Access Compliance Report

Public Rights-of-Way

(Curb Ramps)

Intersection ID: 54779	Main Street: SHARON AMITY RD	Cross Street: CHARLESTON DR	Location: SW
ADA ID: DA567D33130B	Ramp Type: Perp	Initial Pass/Fail: Fail	Overall Compliance: No
Severity Score: 25			
Codes/Mitigation Info/Possible Solution		Field Measurements/Component Compliance

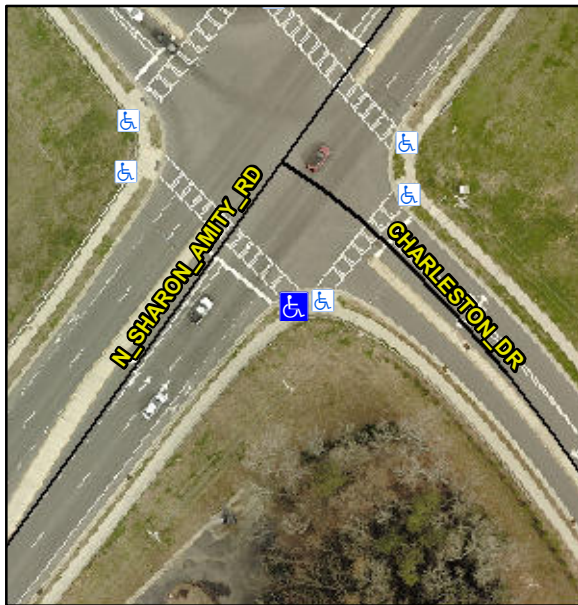
Not Found, R304.5.3

Compliance	Description	Data	Compliance	Description	Data
N/A	Ramp Length (in)	66.0	Yes	Ramp Slope (%)	6.4
Yes	Ramp Width (in)	58.0	No	Ramp XSlope (%)	8.5
N/A	Flare Type LT	N/A	N/A	Flare Type RT	N/A
N/A	Flare Slope LT (%)	N/A	N/A	Flare Slope RT (%)	N/A
N/A	Flare Traversable LT?	N/A	N/A	Flare Traversable RT?	N/A
N/A	Landing Length (in)	N/A	N/A	DWS Provided?	N/A
N/A	Landing Width (in)	N/A	N/A	DWS Contrast?	N/A
N/A	Landing Slope (%)	N/A	N/A	DWS Length (in)	N/A
N/A	Landing X Slope (%)	N/A	N/A	DWS Full Width?	N/A
N/A	Landing Curb? (Y/N)	N/A	N/A	DWS Offset (in)	N/A
N/A	Shared Landing?	N/A			
N/A	Gutter Ponding?	N/A	N/A	Gutter Slope (%)	N/A
N/A	Gutter Lip Ht (in)	N/A	N/A	Gutter X Slope (%)	N/A
N/A	Painted X Walk1?	Yes	N/A	Painted X Walk2?	N/A
	X Walk 1 Direction	To NW		X Walk 2 Direction	N/A
N/A	X Walk 1 Width (in)	108.0	N/A	X Walk 2 Width (in)	N/A
	X Walk 1 Slope (%)	8.1		X Walk 2 Slope (%)	N/A
	X Walk 1 X Slope (%)	5.3		X Walk 2 X Slope (%)	N/A

Remove & Replace Entire Ramp.
